**The manuscript is presenting a modelling concept for evapotranspiration determination of green walls, which is a relevant topic, specifically nowadays when greening infrastructure is a highly recommended measure to reduce urban heat and prevent drought. However, to the reviewer's opinion, the method chosen is inappropriate due to violation of underlying (homogeneity) assumptions in the reference method chosen.**

**Summarizing I recommend either reject (and submit to other journal) or major revision. The above comments are detailed below:**

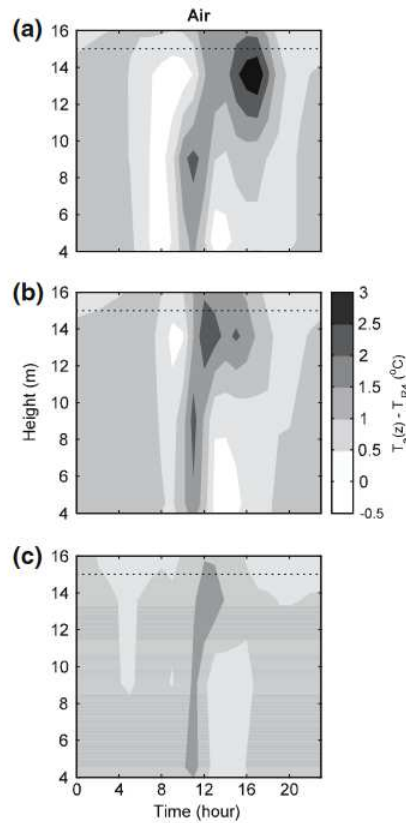
**RC2.17: Page 7, lines 220-221: the fact that certain measurements or simulations are not available does not justify simply ignoring them!**

Thank you very much! With this criticism both reviewers are right! We agree that this paragraph needs clarification and will be revised in the following way: Of course, VPD has a high impact on ET (as shown in Figure 3 in the manuscript), meaning that high variations of VPD lead to high variations of ET. However, the temperature differences in the diurnal course are much higher than the differences in the height profile. As shown in Offerle et al. (2007), see the figure below.

Figure: short wave incoming solar radiation measured onsite on (red) on a horizontal pane and (orange) on a vertical pane. Note that the diffuse radiation.

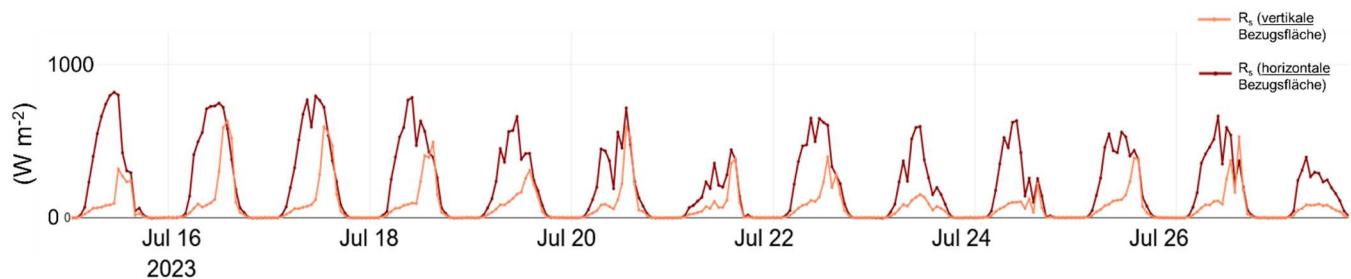
**RC2.36: Page 15, lines 459-460: “First, ET is generally estimated too high”: This is not a reason but an observation.**

This is correct. We change this sentence in the following way: First, ET is generally estimated too high as the energy input from solar radiation is generally higher for the remote, non-verticalized dataset. We would like to draw attention to the following figure showing the differences between the horizontal pane and the vertical pane on: We will add a similar diagram for the according reference time:

Please note that a simple reduction would end in a rather not so simple reduction when it is aimed to reach a certain level of accuracy.
